Enbridge Northern Gateway Project Joint Review Panel

Written Comment Form

PRESENTATION BY THE NORTHERN BRANCH OF THE STEELHEAD SOCIETY OF BC ASKING THE JOINT REVIEW PANEL ON THE PROCEDURAL DIRECTION FOR THE ENBRIDGE NORTHERN GATEWAY PROJECT TO INCLUDE ADDITIONAL ISSUES THAT SHOULD BE DISCUSSED DURING THE ASSESSMENT OF THE PROJECT PROPOSAL AND ADDITIONAL COMMUNITY HEARING LOCATIONS

Volume 7B: Risk Assessment and Management of Spills – Pipelines

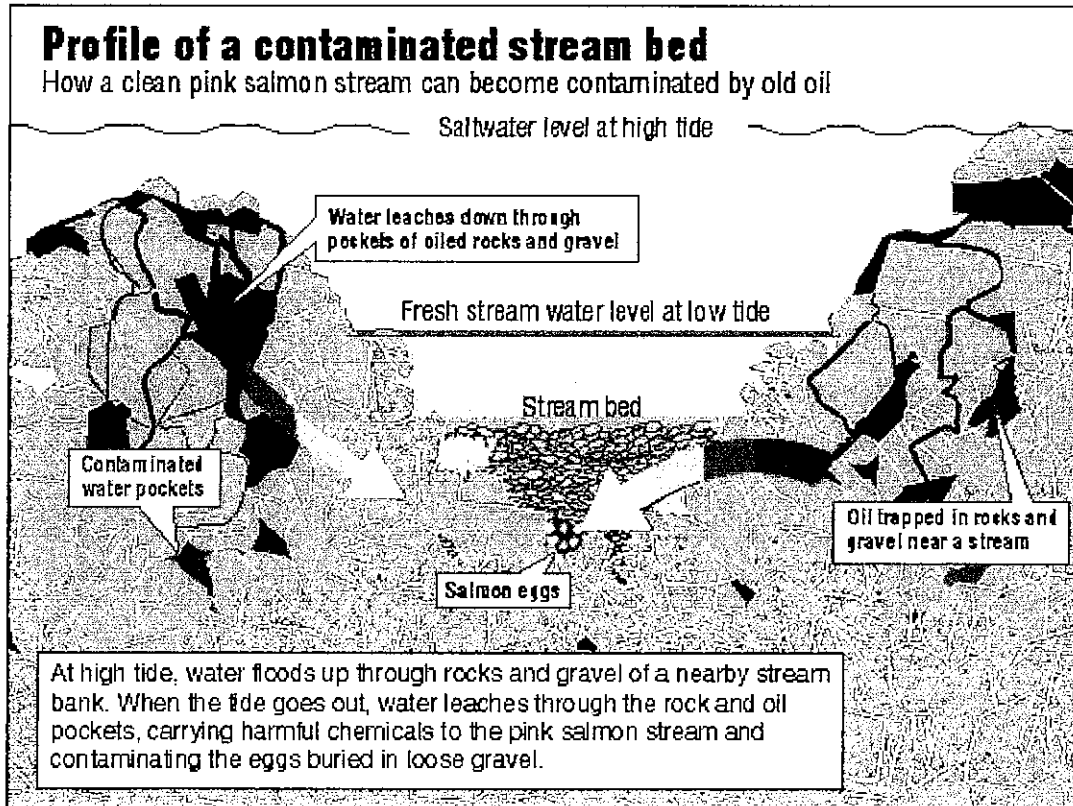
The bottom may well be of smaller aggregate, however there are many point on the river where the banks have been armored with shot rock. These points and the rock can entrap oil and we believe impossible to clean. The following illustration was to illustrate an estuary area. We feel it

is illustrative when the line "saltwater level of high tide" is substituted with "river high water level"

The above illustration holds true for the Morice/Bulkley and the Clore/Copper river systems.
